March 26, 2026
Subject: Joshua Chamberlain Bridge
#5312 Bridge wearing surface
replacement project
State WIN: 025313.00
Location: **Bangor-Brewer**
Amendment No. 1

Please make the following changes to the Bid Documents:

BANGOR & BREWER PENOBSCOT COUNTY JOSHUA CHAMBERLAIN BRIDGE OVER PENOBSCOT RIVER BRIDGE # 5312 WIN 025313.00

PIER 11 BRIDGE JOINT MODIFICATION TYPE 3

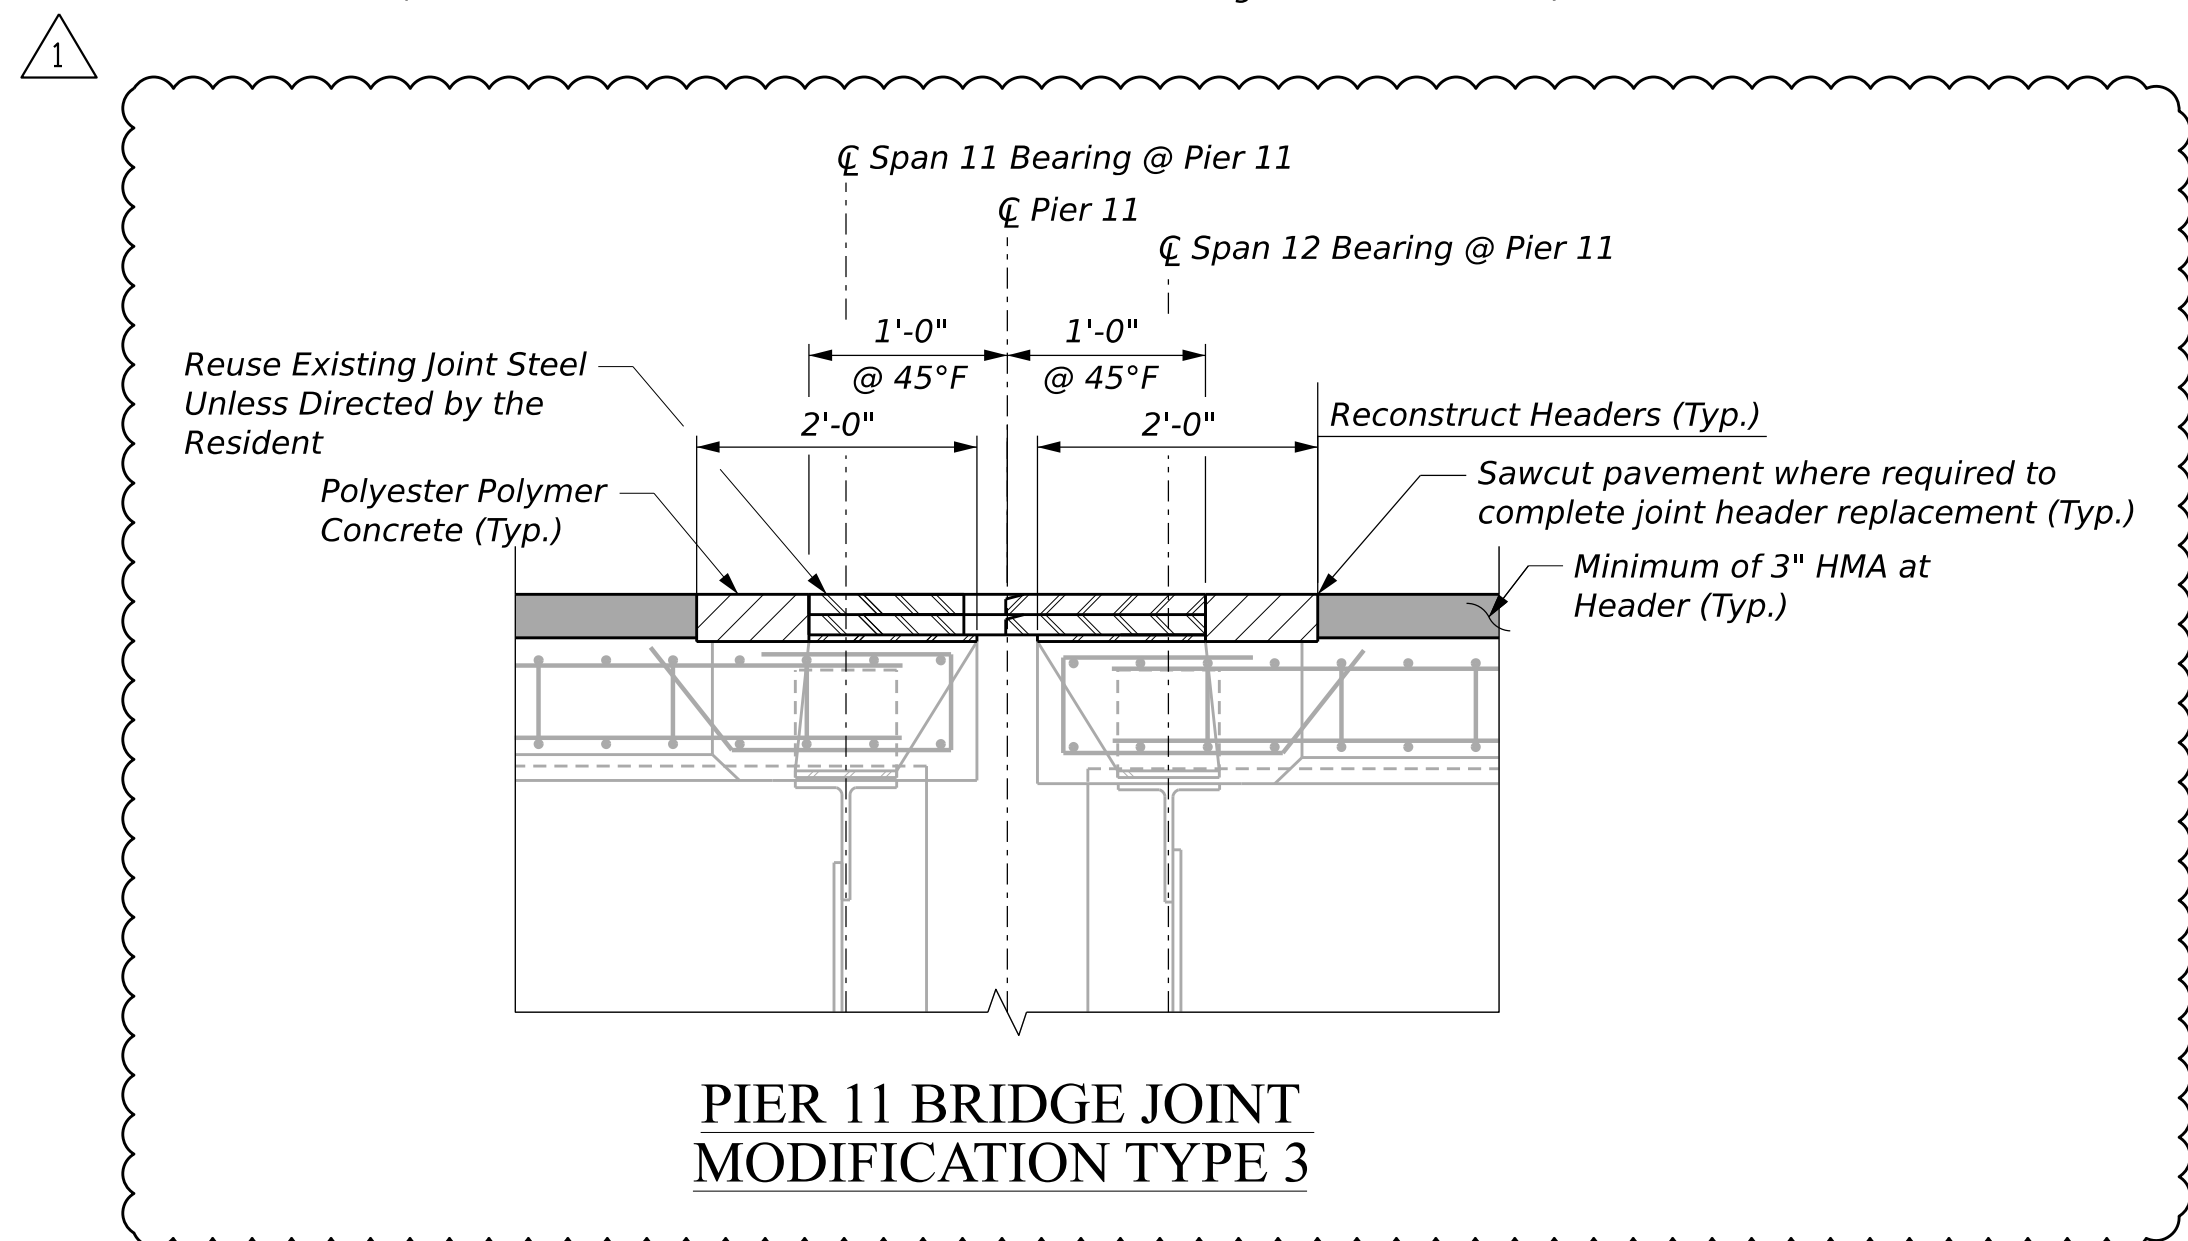
The plan set is being **Replaced** in its entirety. Please refer to the attached updated set of plans with 12 pages. A modular joint will not be installed at pier 11 as part of this contract.
